Explanation of Request: Site Plan & Design approval to develop a multi-family residential project with +/- 394 units.

**Subject: Modera Hollywood
Application No. 23-DP-14
Comment Responses**

Response Date: October 10, 2023

DYI - FAR DH2 & DH3 AREAS
1/4" = 1'-0"

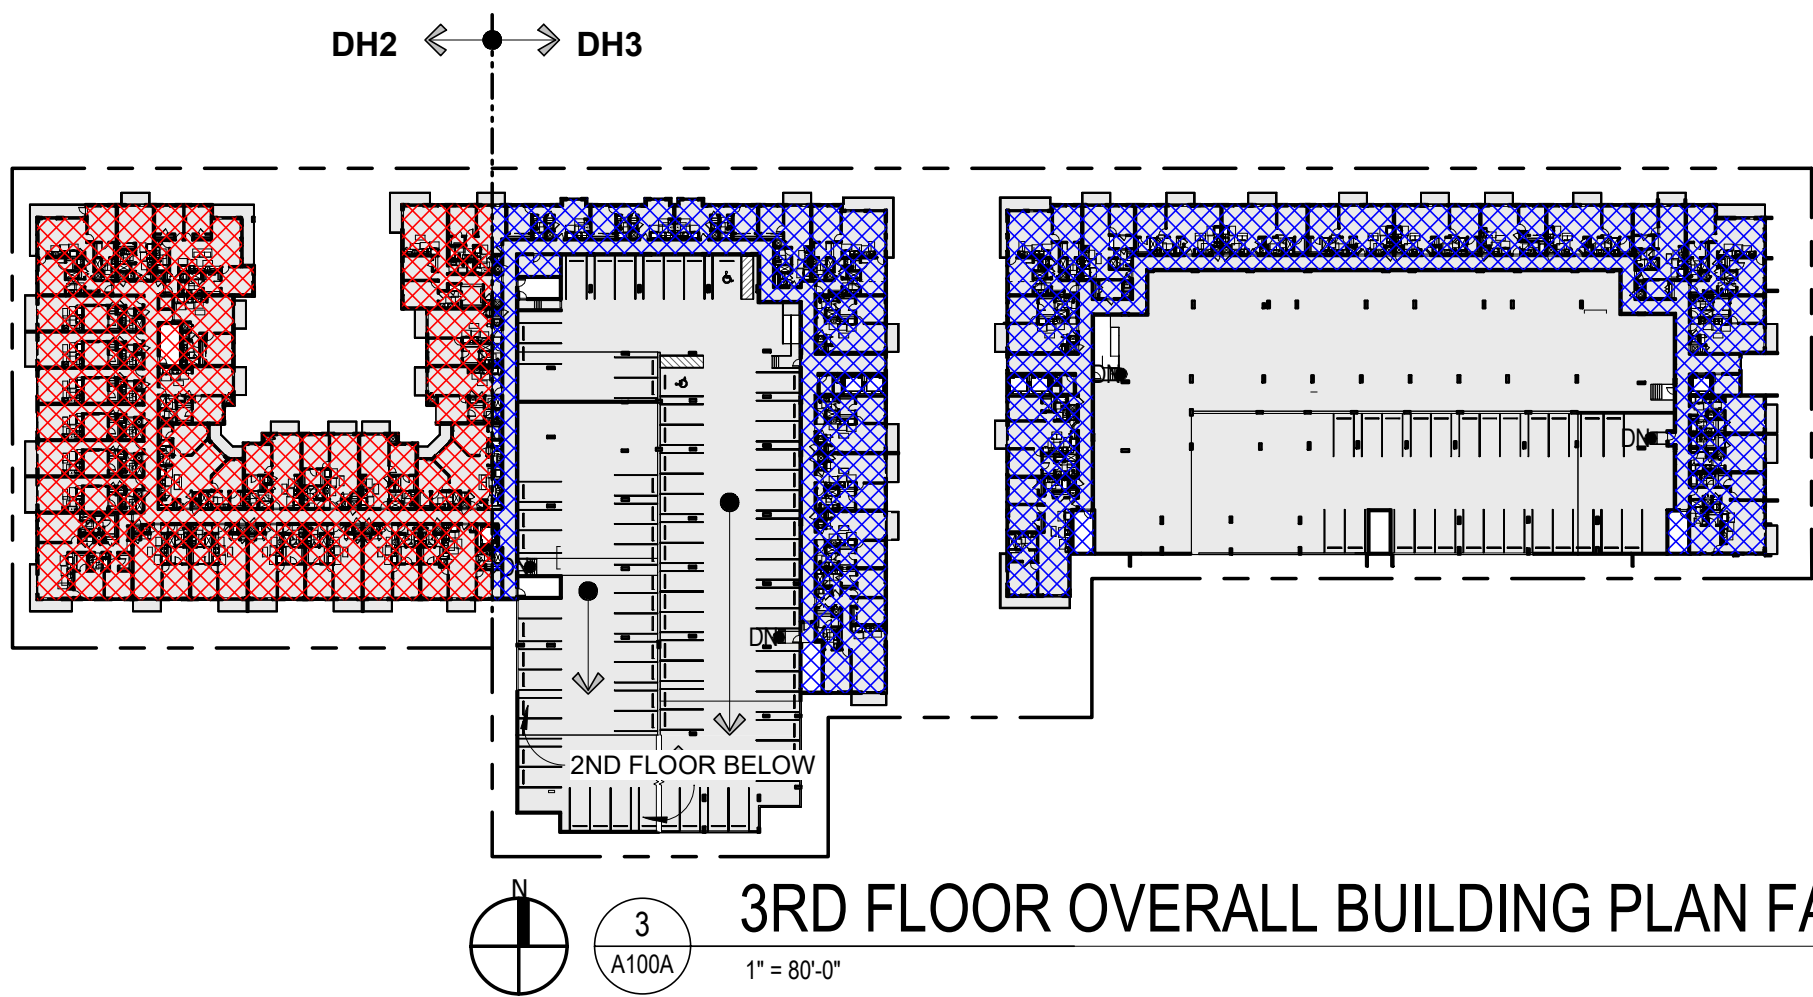
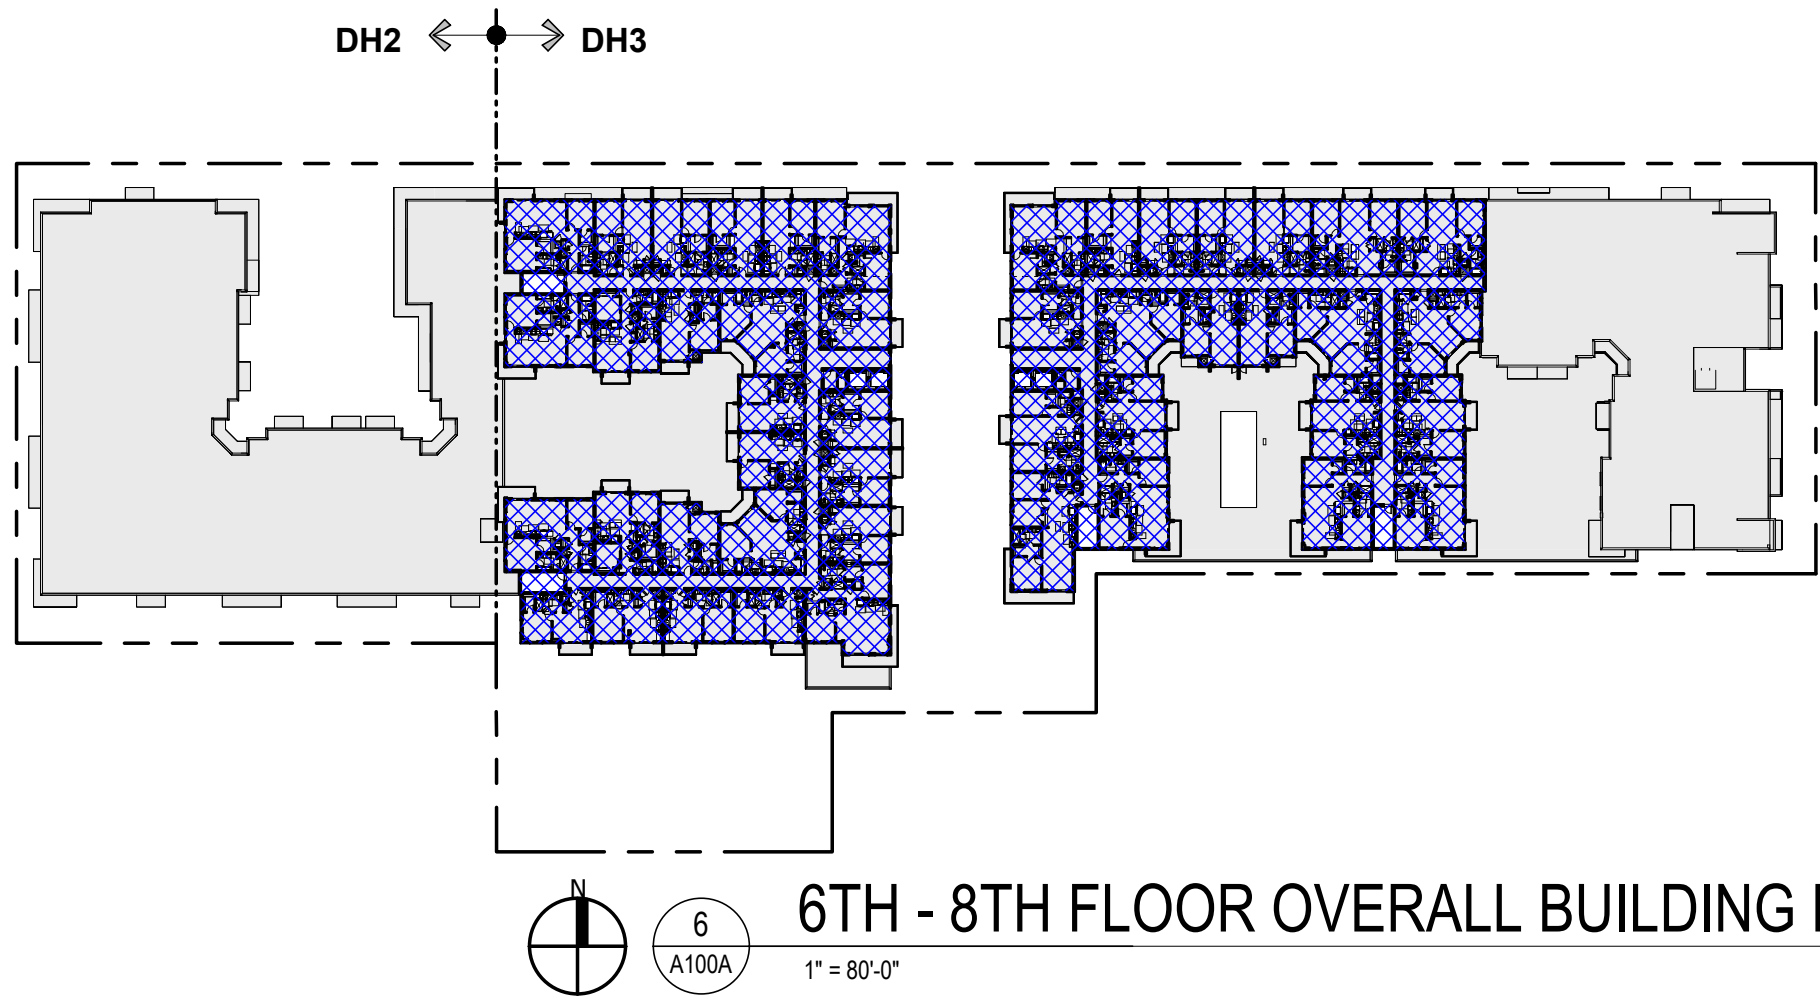
3. Show a diagram how the FAR has been calculated. Please provide on a separate sheet.

Response: Refer to the new sheet A100A with FAR calculations and diagrams with shaded areas that are included in FAR calculation.
